Keystone RV Company

SAFETY ADVISORY 25-463

7-Way Cord and 12V Distribution Box Wiring

Fig. 1 Incorrect Wiring

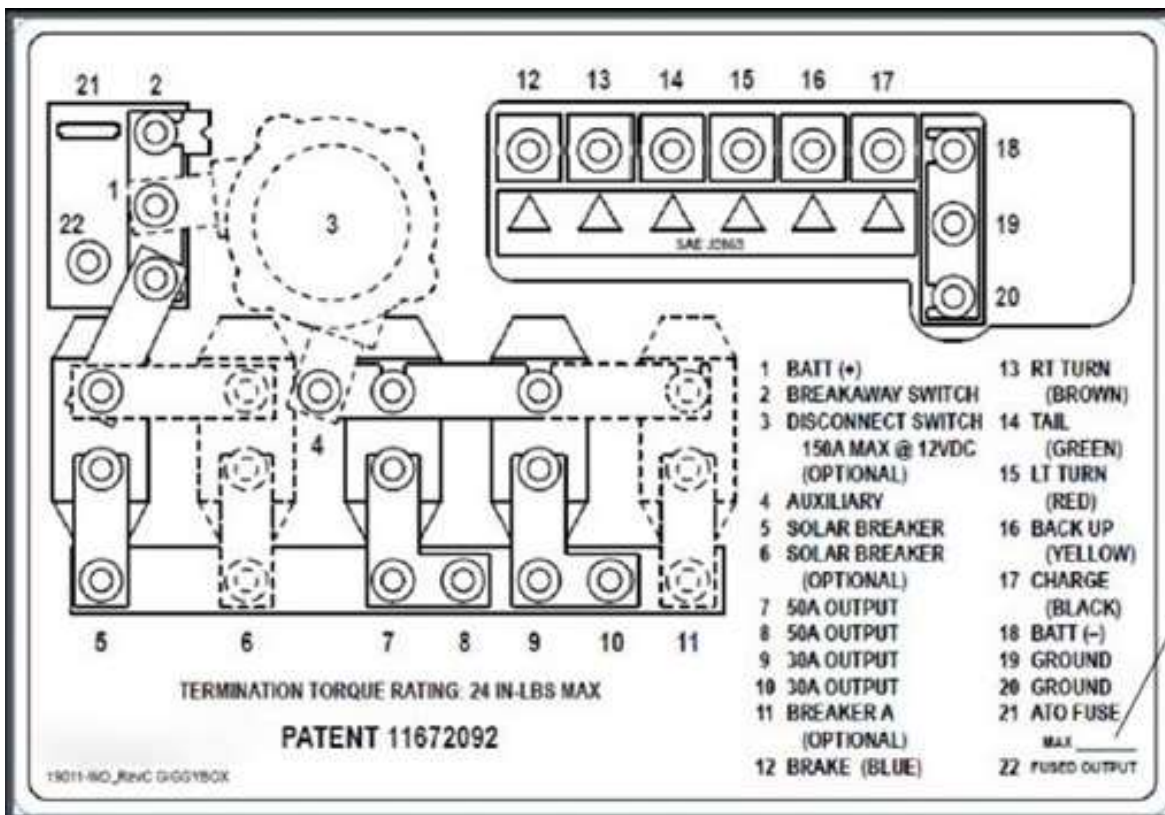
Keystone is conducting a voluntary RECALL notification campaign in accordance with the National Highway Transportation and Safety Act. It has been decided the 7-way cord and 12V distribution box wiring may have been hooked up incorrectly. Under certain conditions during travel, the charge line may not be properly protected leading to an increased risk of fire. The following procedure describes how to identify and repair wiring.

Inspect wiring at 12V Distribution box. See **Figure 1** incorrect location of wiring. If correct according to **Figure 2** correct location of wiring, proceed to claim inspection. No further action is required. If incorrect proceed to **Step 4**.

Repair wiring according to **Figure 2**.

- Starting by moving wire from slot 22 to slot 1, which is the battery terminal.
- Ensure that slot 5 is connected to the red wire.
- Ensure that slot 6 is empty.
- Ensure slot 7 has the red wire.
- Ensure slot 9 has the purple wire as well as black wire.
- Next ensure slot 10 is the brown wire and brown/ white wire, one side of the red jumper.
- Slot 17 is the other end of the red jumper wire.
